**Milford Welcome Center
Home of the Milford Museum
400 NE Front Street Milford, Delaware
Project No. 1884A003.A01
Bid Pac A – Contracts 1 thru 9
February 28, 2025**

Addendum No. 1

Dwg.No.: **A-501**

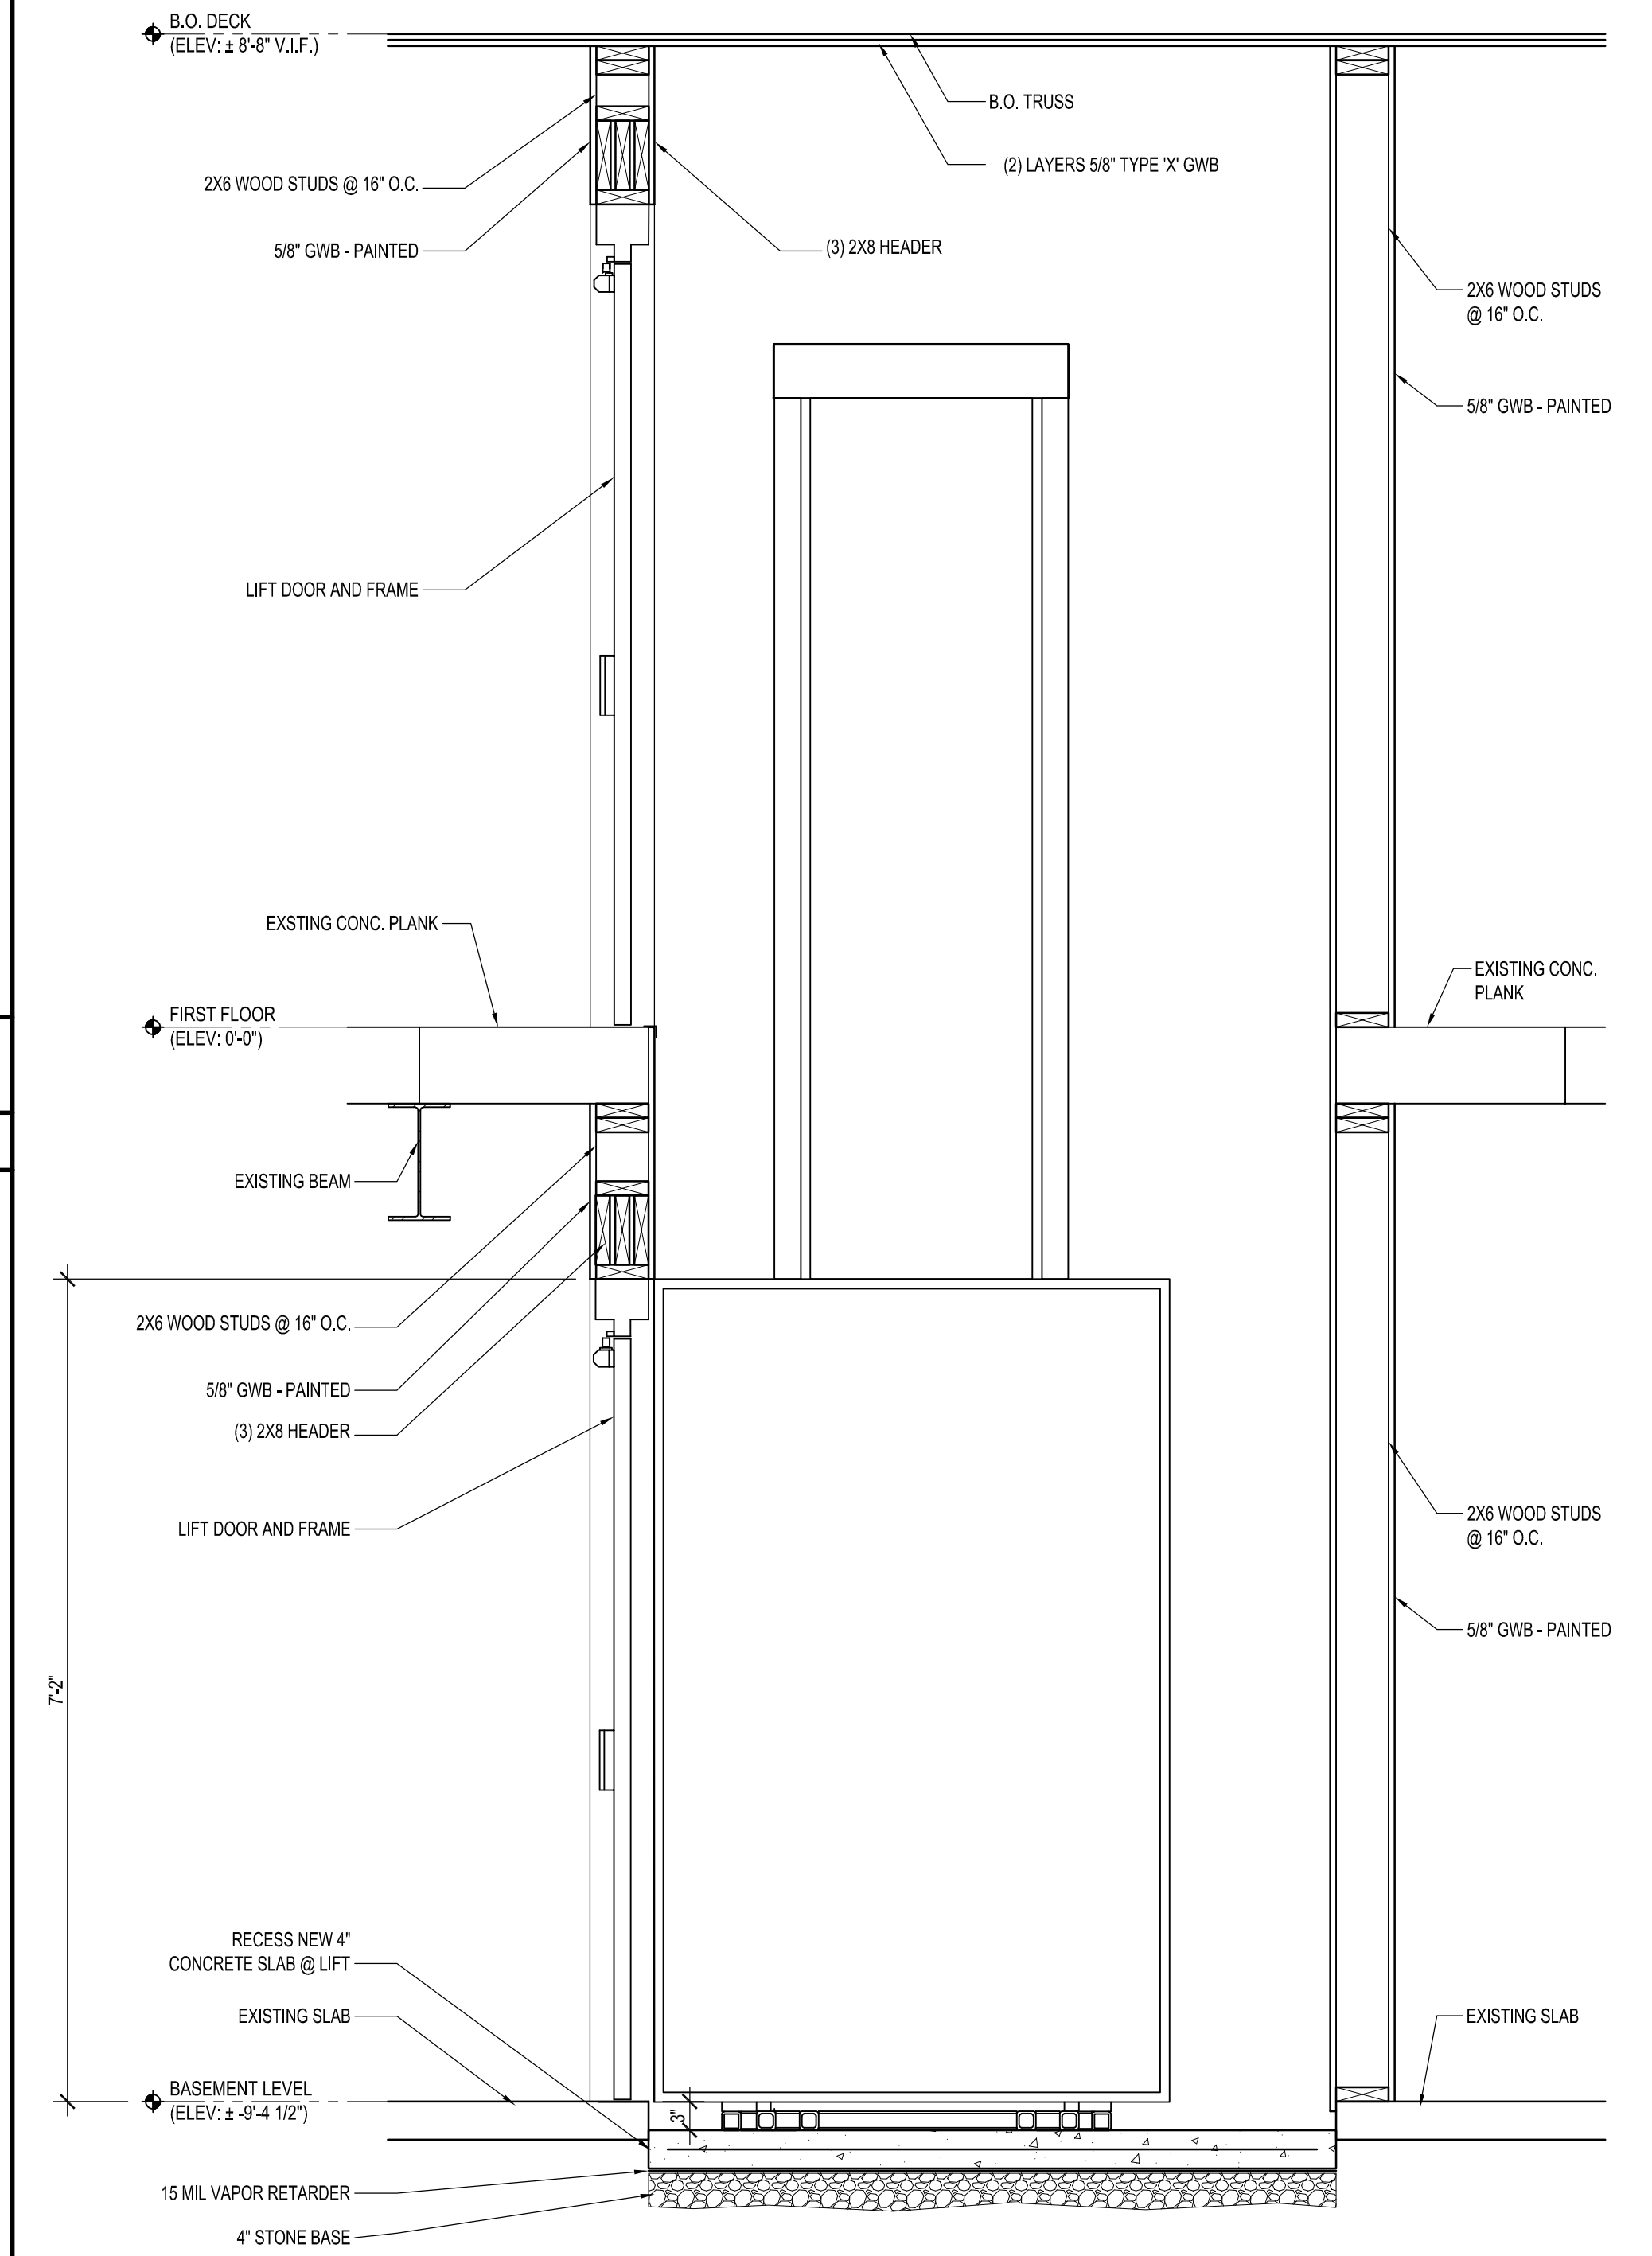
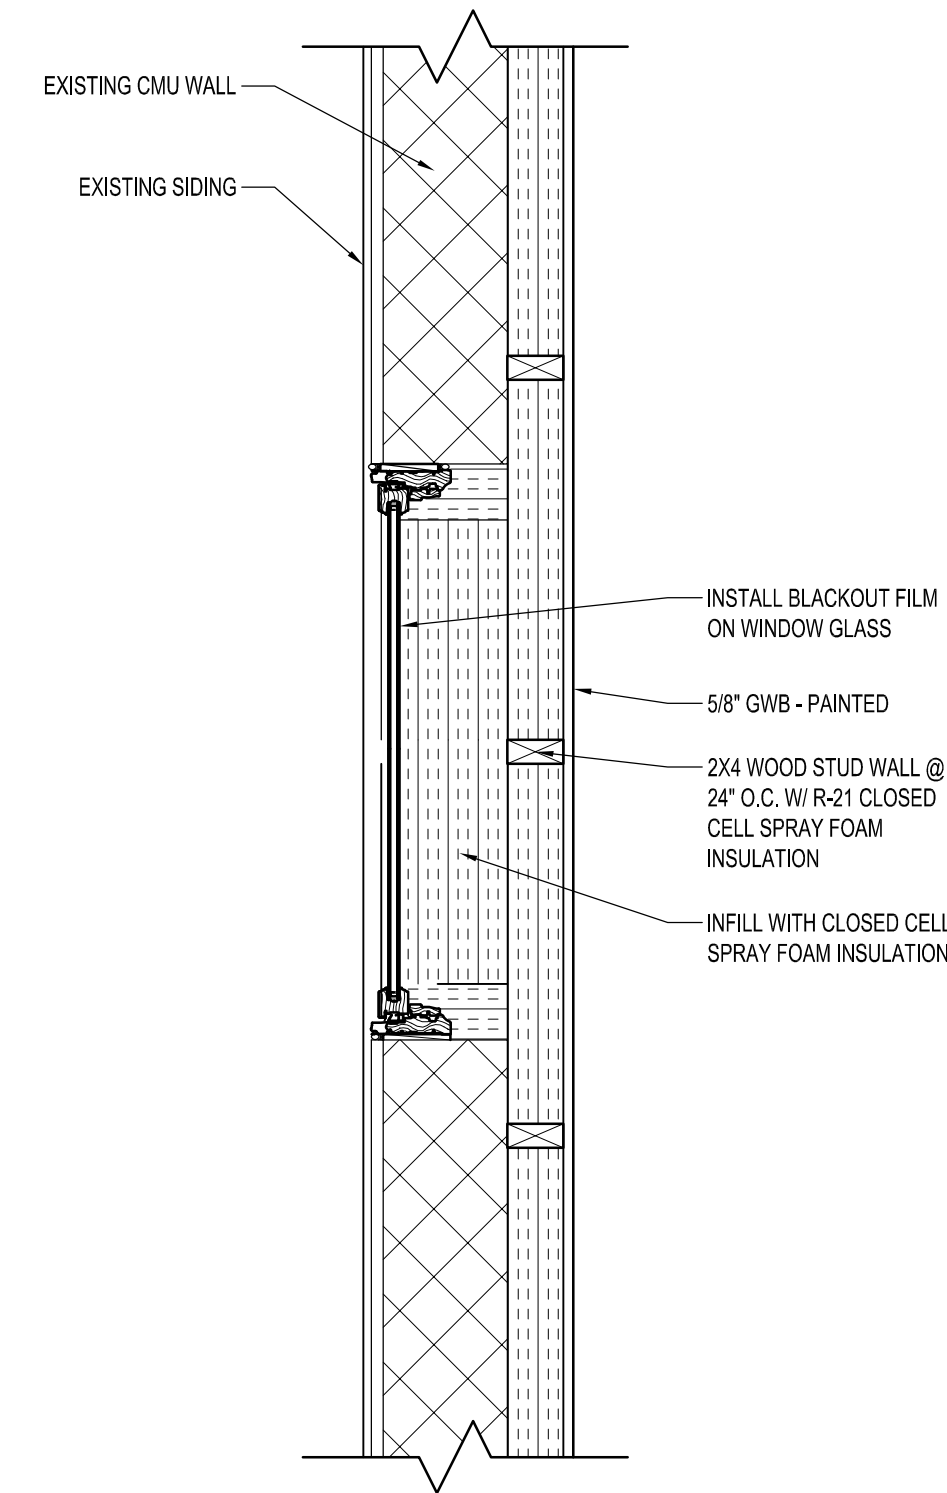
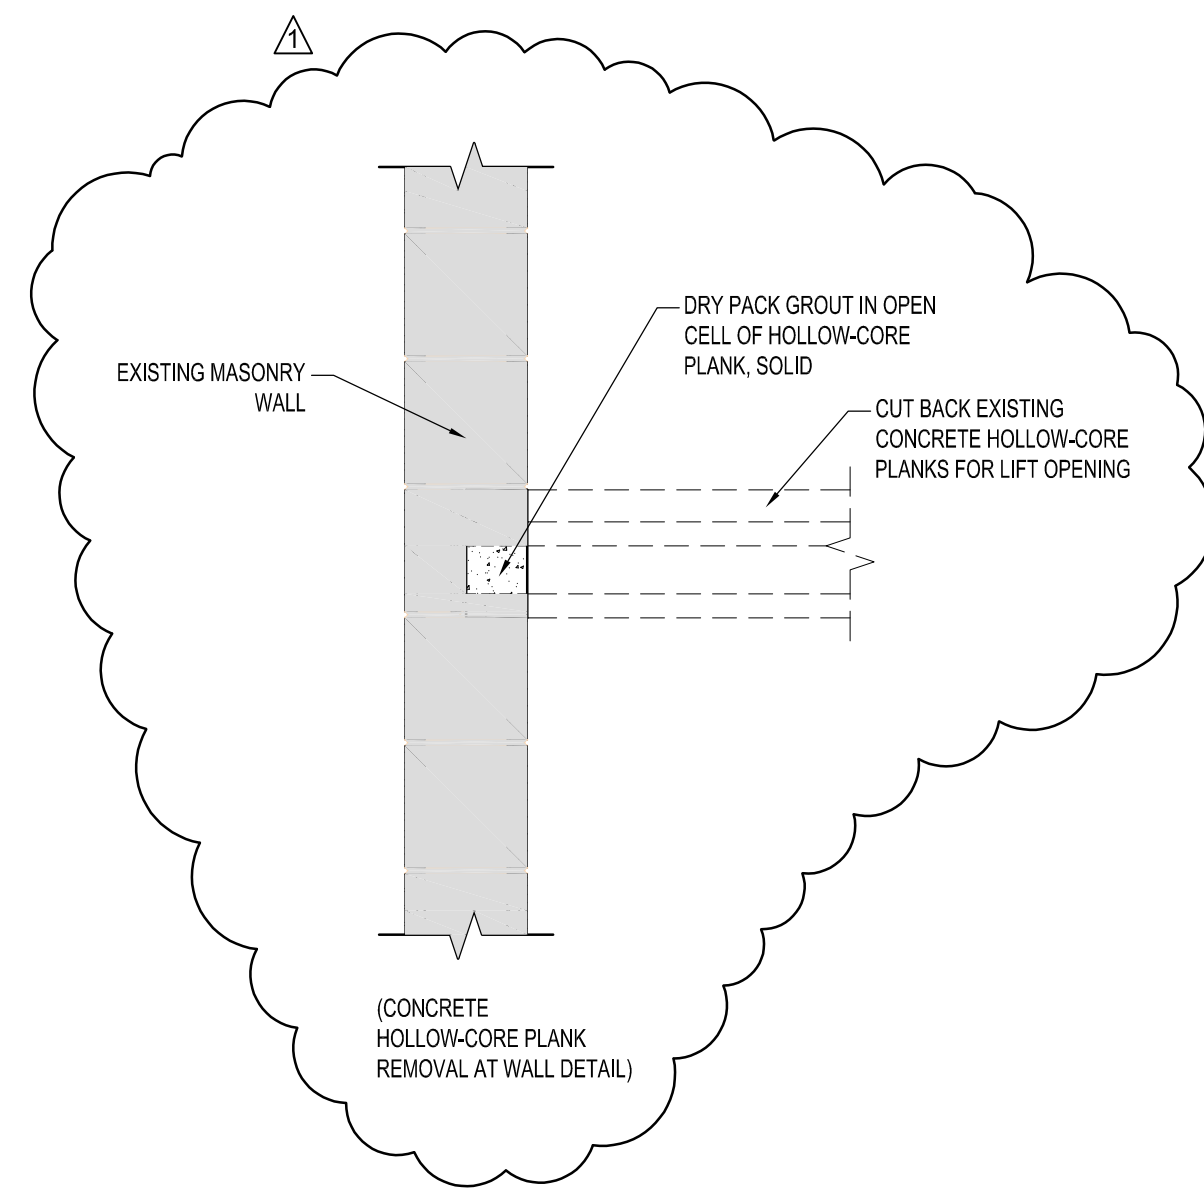
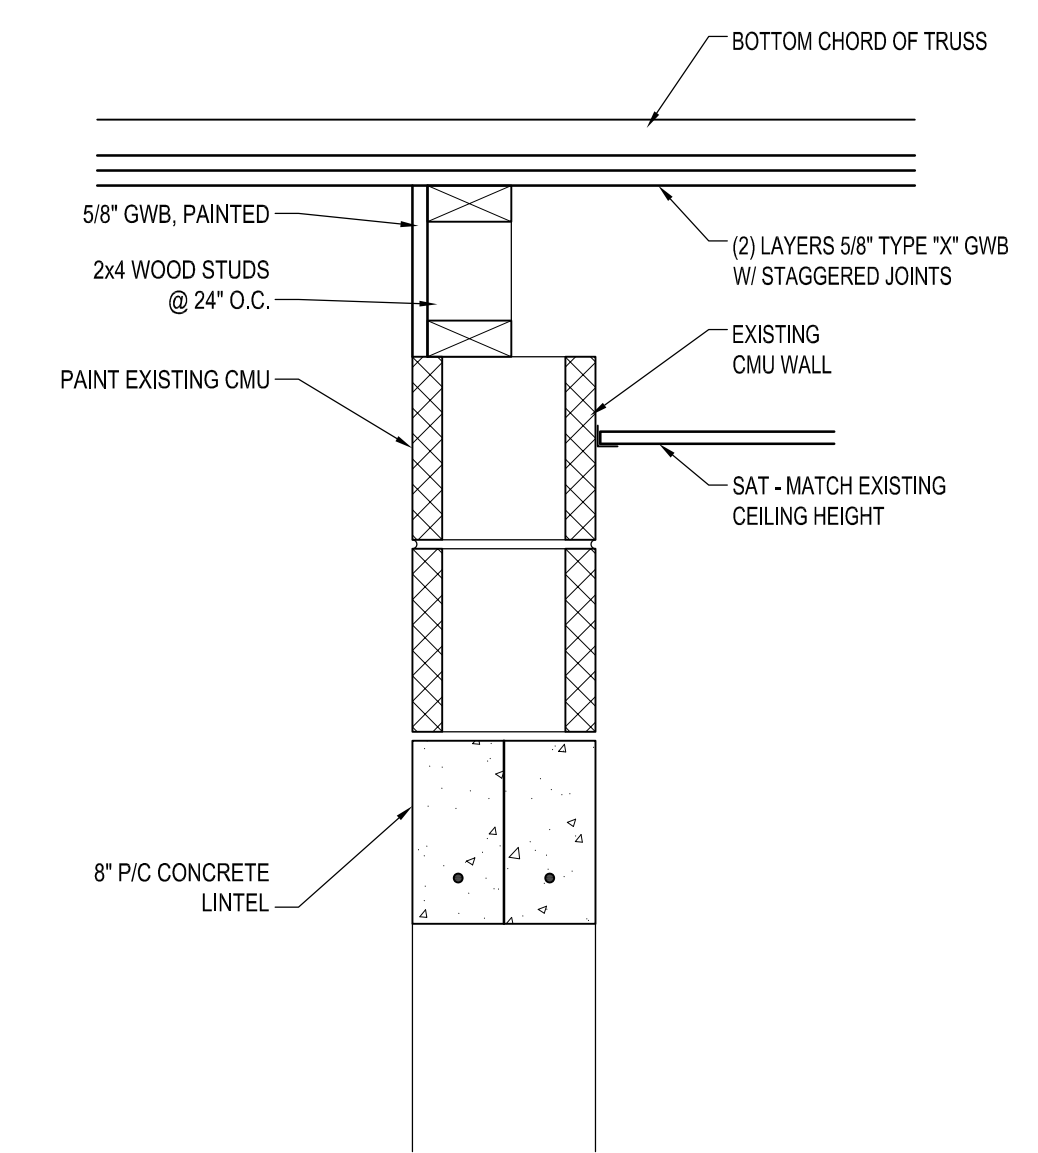
DATE	COMMENTS
02/26/2025	DETAIL ADDED
